STAFF RECOMMENDATION
1902 Bernard Avenue
August 15, 2018

Application: New Construction—Infill
District: Belmont-Hillsboro Neighborhood Conservation Zoning Overlay
Council District: 18
Map and Parcel Number: 10412015700
Applicant: Tyler LeMarinel, Allard Ward Architects
Project Lead: Melissa Baldock, melissa.baldock@nashville.gov

<p>Description of Project: Application is to construct new infill development.</p> <p>Recommendation Summary: Staff recommends approval of the infill with the following conditions:</p> <ol style="list-style-type: none">1. The finished floor height shall be consistent with the finished floor heights of the adjacent historic houses, to be verified by MHZC staff in the field;2. Staff approve the front setback staking to ensure that it matches the front setback of the house next door at 2017 19th Avenue South;3. A walkway leading from 19th Avenue South to the front porch be added;4. Staff approve a brick sample, all windows and doors, and the shingle selection prior to purchase and installation of these materials; and5. The HVAC be located behind the house or on either side, beyond the mid-point of the house. <p>With these conditions, staff finds that the pro

Site Layout Plan

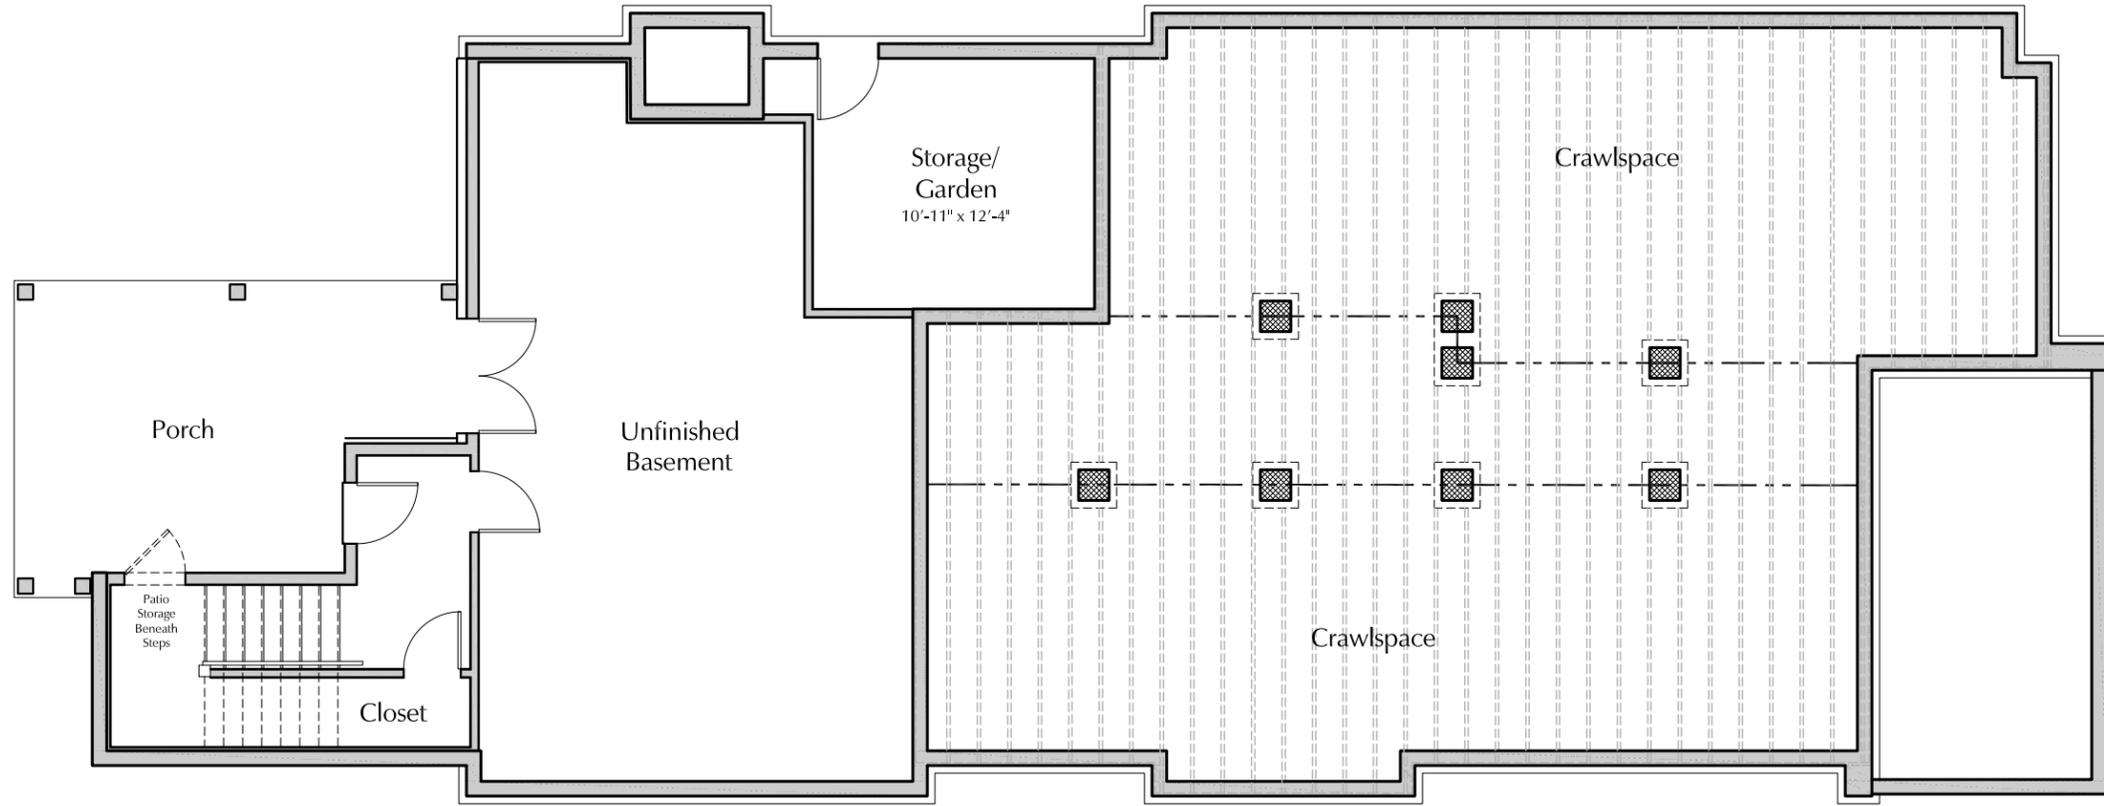
Setback & Rhythm of Spacing: The proposed infill meets all base zoning setbacks. Base zoning requires a minimum ten foot (10’) side setback from the side street, Bernard Avenue. The infill will be ten feet (10’) from the Bernard Avenue’s side property line and five feet (5’) from the right/north side property line. It will be over seventy-five feet (75’) from the rear property line. The front setback will be approximately twenty-three feet, four inches (23’4”) from the front property line. This is to match the front setback of the historic house next door at 2017 19th Avenue South. Staff recommends that MHZC staff inspect the field staking to ensure that the infill’s front setback does match that of 2017 19th Avenue South. With this condition, staff finds that the infill meets Section II.B.1.c. of the design guidelines.

Orientation: The proposed infill is oriented towards 19th Avenue South, which is appropriate. Even though the existing non-contributing house on the lot is oriented towards Bernard Avenue, the side street, new development on a corner lot is typically required to be oriented towards the narrowest part of the lot, which in this case is 19th Avenue South. Orientation to 19th also matches the historic development pattern. The infill has a partial width front porch with a depth of approximately nine feet, six inches (9'6"). Vehicular access to the lot can be via the rear alley. Staff recommends the inclusion of a walkway from the sidewalk on 19th Avenue South to the front porch. With

Appurtenances & Utilities. The location of the HVAC and other utilities was not noted. Staff recommends that the HVAC be located on the rear façade, or on a side façade beyond the midpoint of the house. As mentioned under "Orientation," staff also recommends that a walkway be added, leading from 19th Avenue South to the front porch.

1. The finished floor height shall be consistent with the finished floor heights of the adjacent historic houses, to be verified by MHZC staff in the field;
2. Staff approve the front setback staking to ensure that it matches the front setback of the house next door at 2017 19th Avenue South;
3. A walkway leading from 19th Avenue South to the front porch be added;
4. Staff approve a brick sample, all windows and doors, and the shingle selection prior to purchase and installation of these materials; and
5. The HVAC be located behind the house or on either side, beyond the mid-point of the house.

1 East Elevation

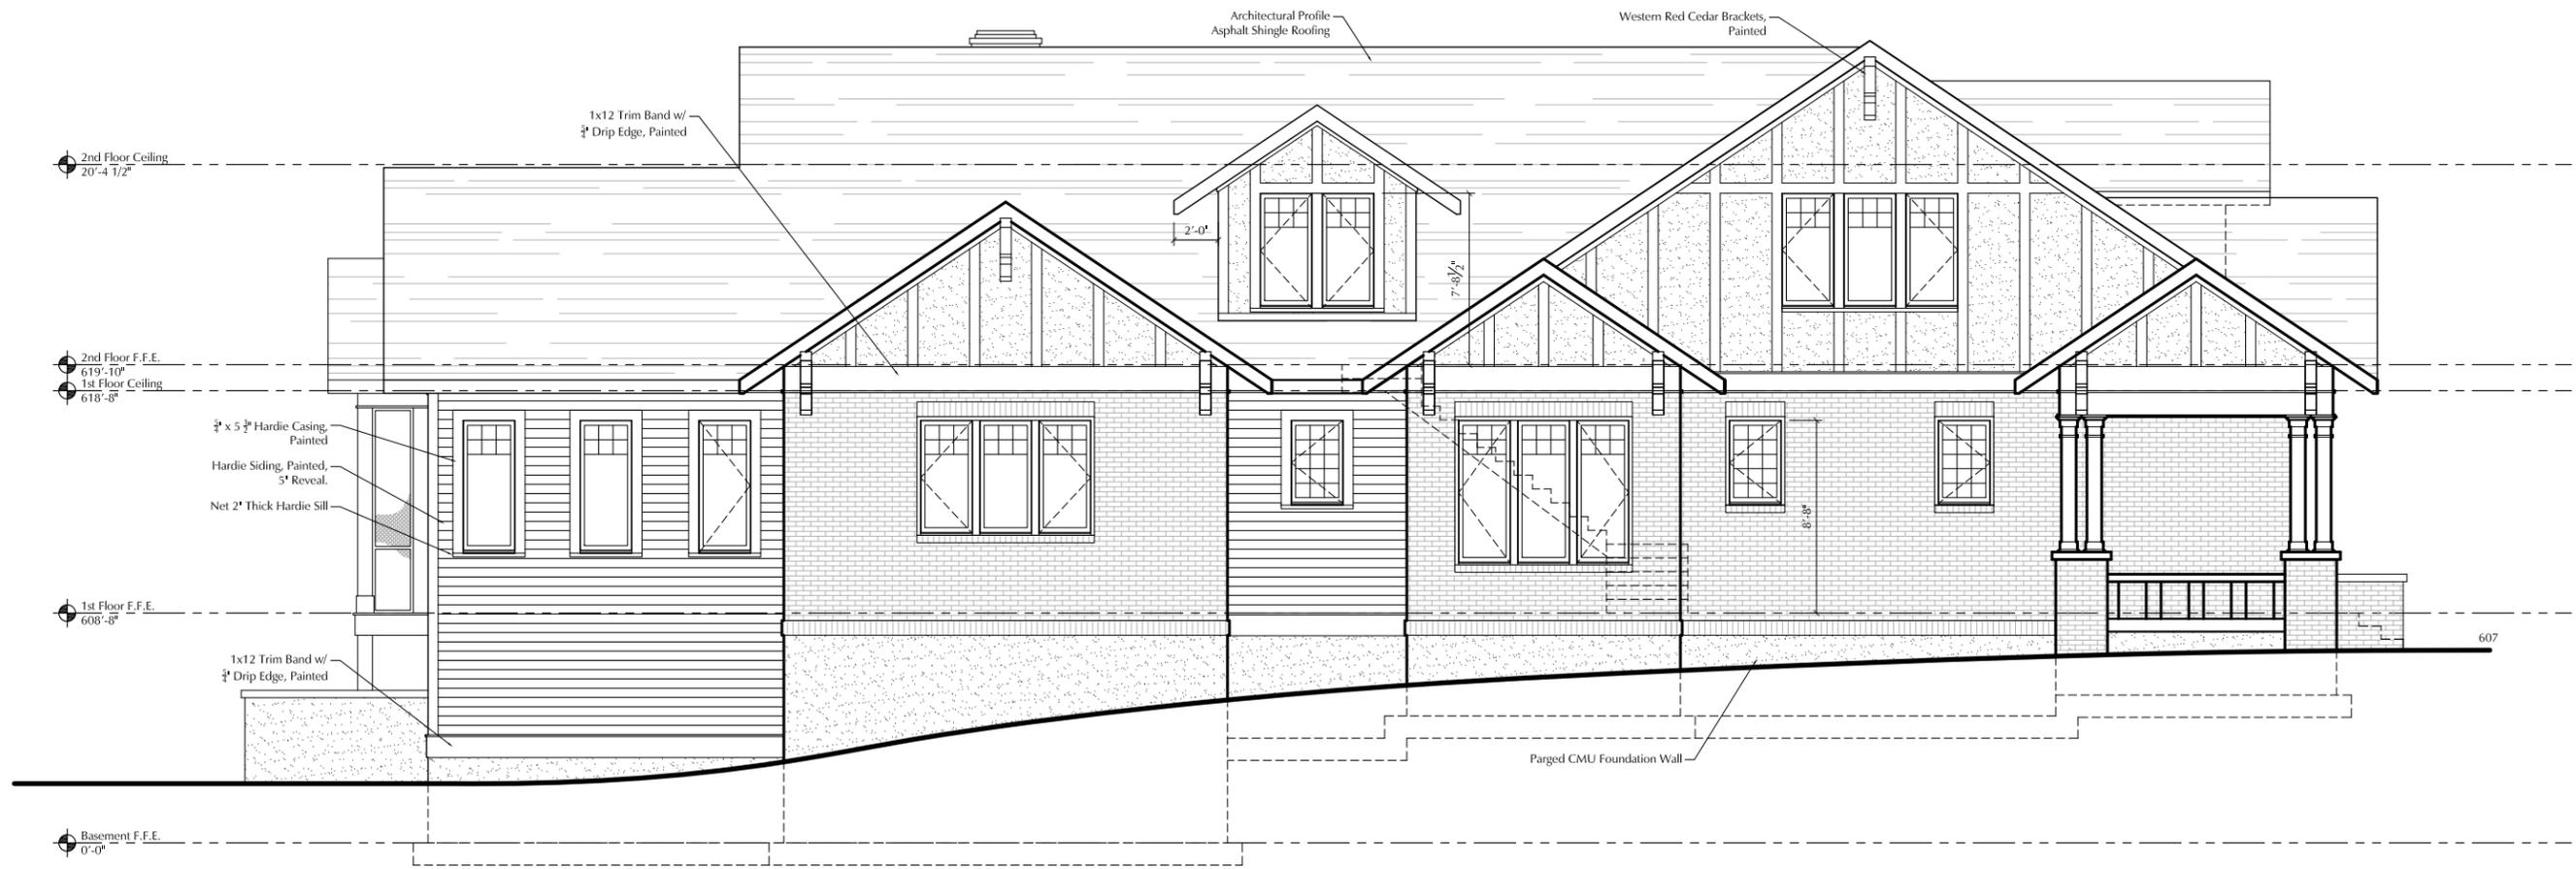
Height & Scale: The proposed infill is one and one-half stories at the front with a height of twenty-seven feet, five inches (27’5”) at the front. Staff finds this to meet the historic context, where historic houses in the immediate vicinity are predominantly one-and-a-half stories in height, with heights between twenty-two and thirty feet (22’-30’). The historic house next door at 2017 19th Avenue South is also one-and-a-half stories with a height of approximately twenty-seven feet (27’).

Roof form: The primary roof form is a side gable with a slope of 8/12. The infill's one story bays, porches, and dormers all also have gables with a slope of 8/12. The front and side dormers are set back a minimum of two feet (2') from the wall below, as is typically required. Staff finds that the proposed roof forms meet Section II.B.1.e. of the design guidelines.

Proportion and Rhythm of Openings: The windows on the proposed infill are all generally twice as tall as they are wide, thereby meeting the historic proportions of openings. There are no large expanses of wall space without a window or door opening. All paired and triple window openings have a four to six inch (4"-6") mullion in between them. Staff finds the project's proportion and rhythm of openings to meet Section II.B.1.g. of the design guidelines.
